DATE: April 6, 2010

SUBJECT: Traffic Signal Structural Supports Update and Clarification to Strike-off letter 470-09-3

470-09-3

SUBJECT: Traffic Signal Supports
Supplemental Installation and Inspection Procedures

EXAMPLE 1: Simplex Connection with Threaded Plate (**NOT APPROVED**)

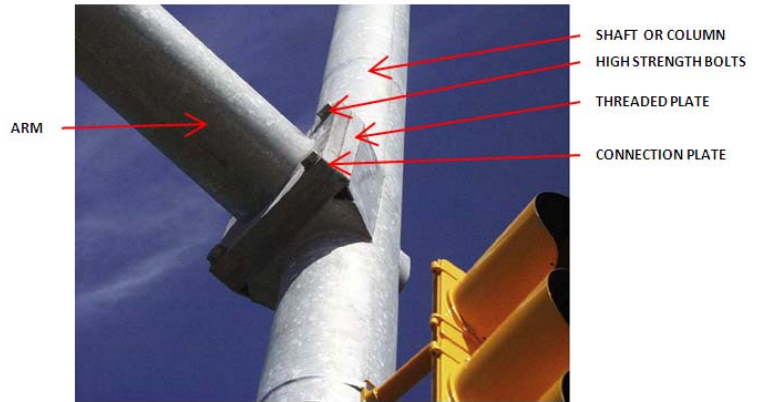
Based on our review of the applicable American Association of State Highway and Transportation Officials (AASHTO) and Department specifications, we will no longer approve threaded plate connections submitted by a manufacturer which are detailed as indicated in Example 1 of Attachment C. This prohibition is being made because the connection detail does not allow for either ‘Rotational Capacity Testing’ or ‘Pre-installation Verification’ testing to be performed prior to installation.

The following note should be added to all new and updated Traffic Signal Permit Plans:
“Threaded plate mast arm connections will not be permitted for this Traffic Signal Permit.”

Projects which were approved prior to this notification utilizing the threaded plate detail will require the manufacturer or contractor to provide Direct Tension Indicators (DTI) to be used during installation. The use of DTIs allows for installation inspection to ensure that the required tension in the connection has been applied. Please note that Section 1105.02(d)6 of Publication 408 requires sampling, testing and approval of the DTI lot by the Bureau of Construction and Material’s Materials and Testing Division prior to use.

EXAMPLE 2: Simplex Connection with hardened washer and nut (**APPROVED**)

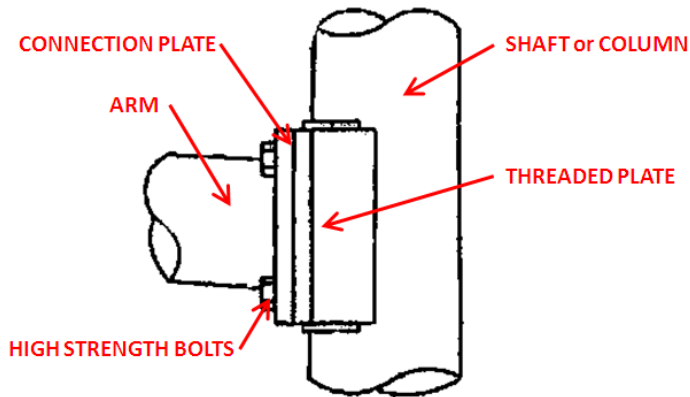
As indicated in SOL 470-09-3, PennDOT’s current high strength bolt installation testing and inspection procedures (PTM’s 427 and 429) contained in Publication 19 “Field Testing Manual” should continue to be used for mast arm-column connections provided as detailed in Example 2 of Attachment B.
